## **Addendum #2**

Old Highway 441 Intersection with CR-46

Project No. 2010-22

Bid No. 10-0046

SHT  
3

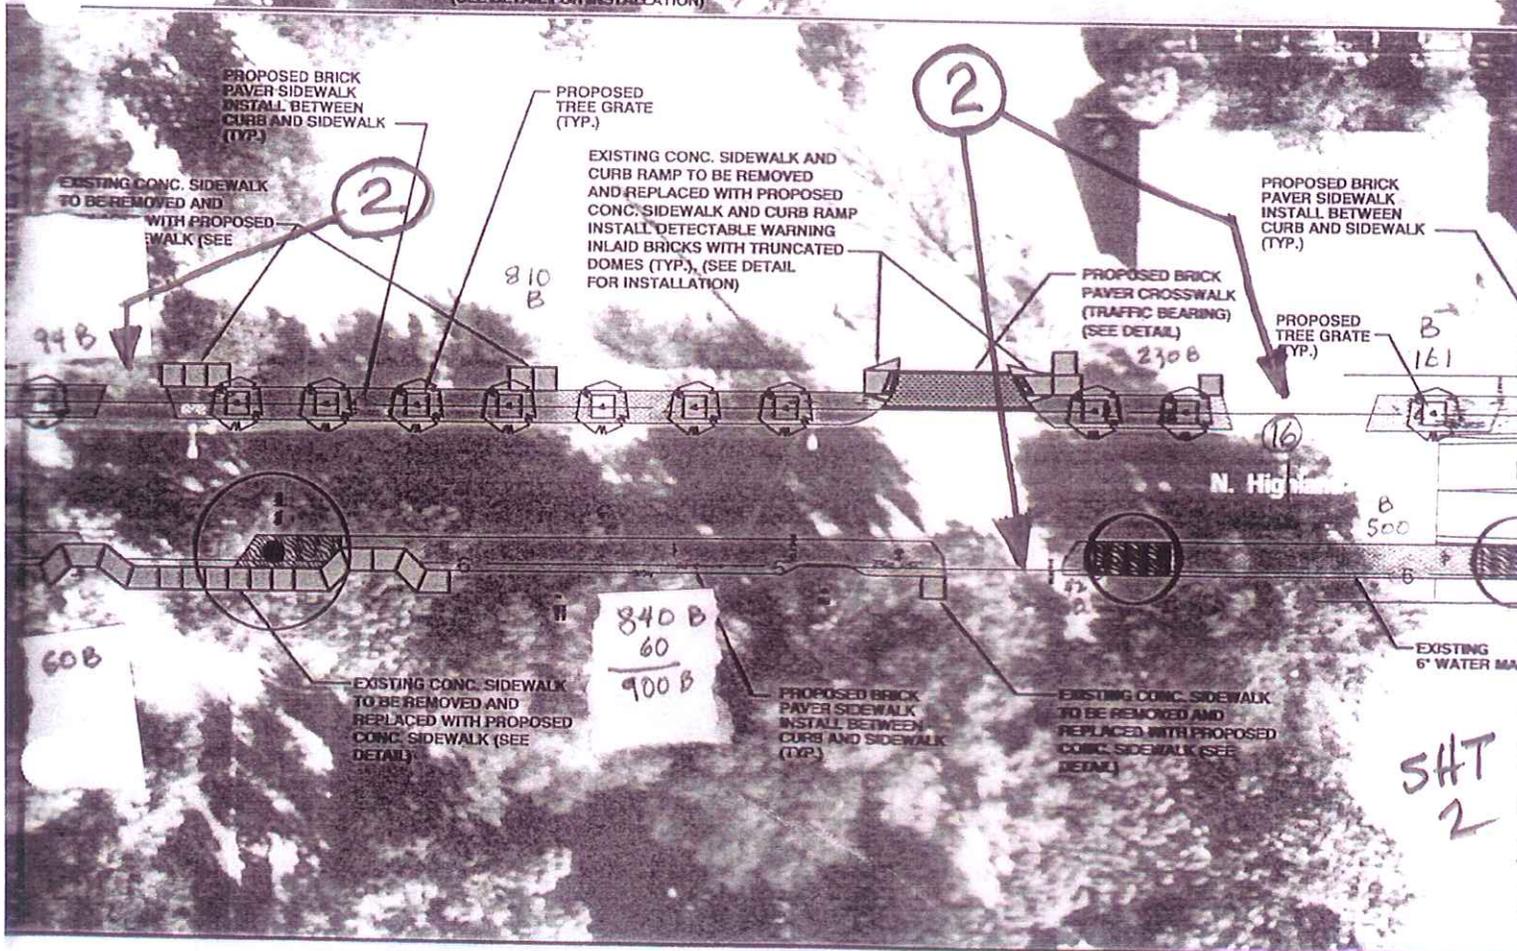
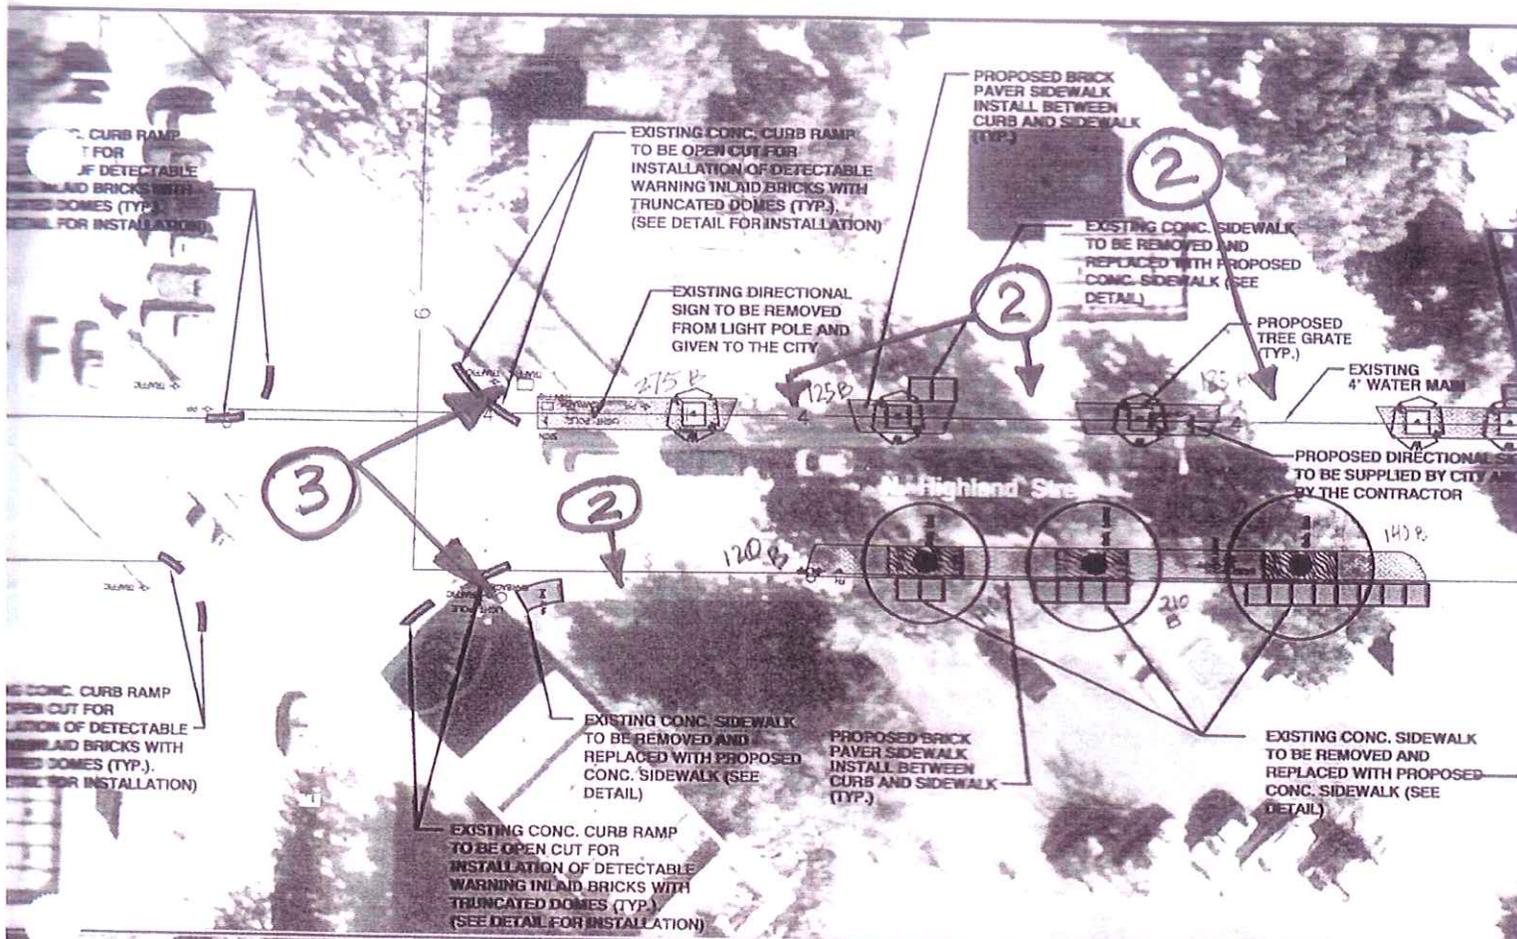
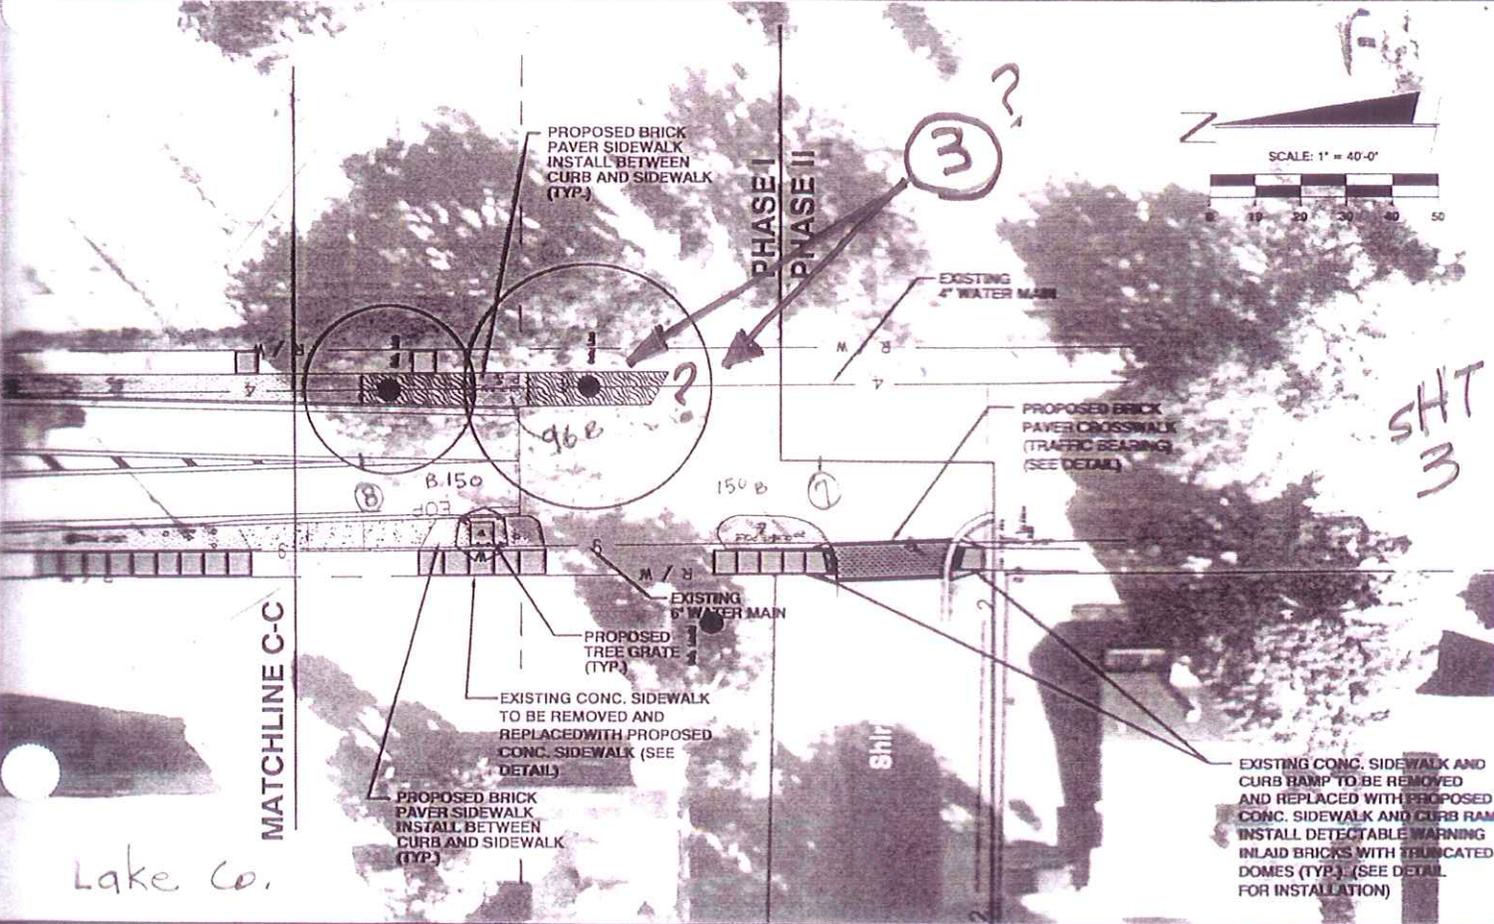
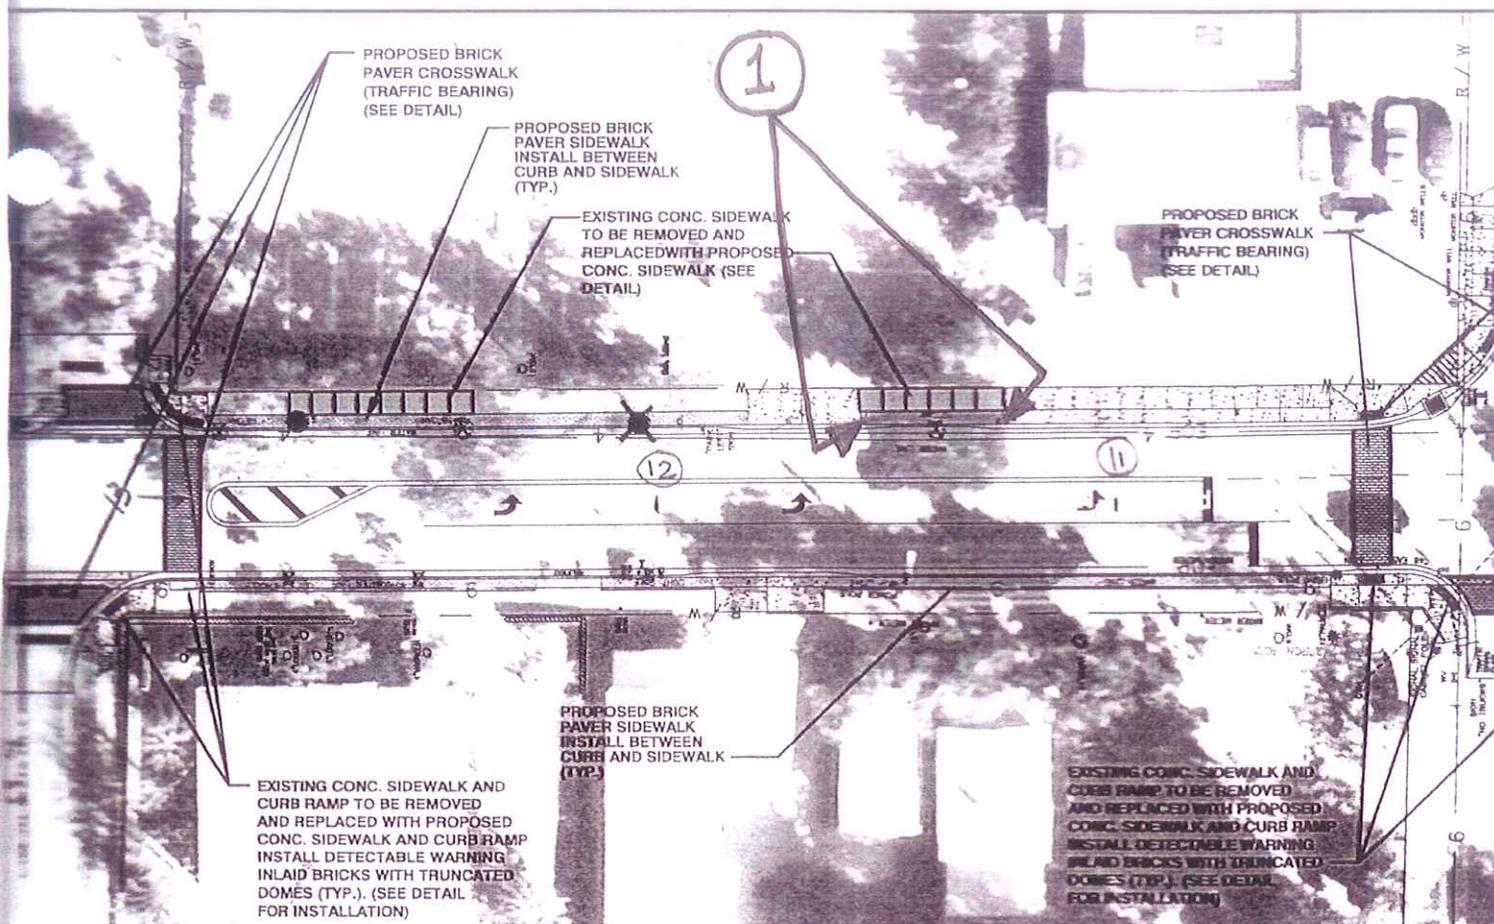
- Q1. Is area noted #1 brick pavers? Documents are too dark to tell. See sht. 3 of Mt Dora portion of the plans and attached copy.
- A1. The area noted #1 on the submitted copy is concrete, as per the Lake County Construction Plan sheets.

- Q2. The extent of concrete sidewalks is unclear on Mt. Dora portion of the plans. See areas noted #2 on attached copy, various areas. Is there new sidewalk here?

Q3. Where does concrete sidewalk begin and end? See note #3 on attached copies.

Q4. Note that a crosswalk is shown on the Mt. Dora plans that is not shown on Lake County Construction Plans. Please refer to sht. 9 of Lake County Construction Plans and sht. 3 of Mt. Dora Construction Plans. See south end of 2<sup>nd</sup> Ave. intersection. Is there a brick crosswalk at this location?

- A2. Sidewalks slated for replacement are clearly delineated on the plans with both shading, as well as a call-out reading "Existing conc. sidewalk to be removed and replaced with proposed conc. sidewalk (see detail)". The minutes from the pre-bid meeting indicate that all portions of sidewalk within the scope of the Lake County roadway portion of the project are to be replaced. The sections to be replaced outside of the Lake County roadway portion of the project are indicated on the Mount Dora sheets.

A3. The area provided on the figure sent with this question called out with the #3 consists of landscape islands, not concrete sidewalk. Note, the plans provided by the City of Mount Dora to Lake County for bidding were in color, and all work is plainly and clearly shown. If you have obtained a set of plans which is not in color, contact Lake County for an original copy.

A4. Yes, there is a brick crosswalk at this location.
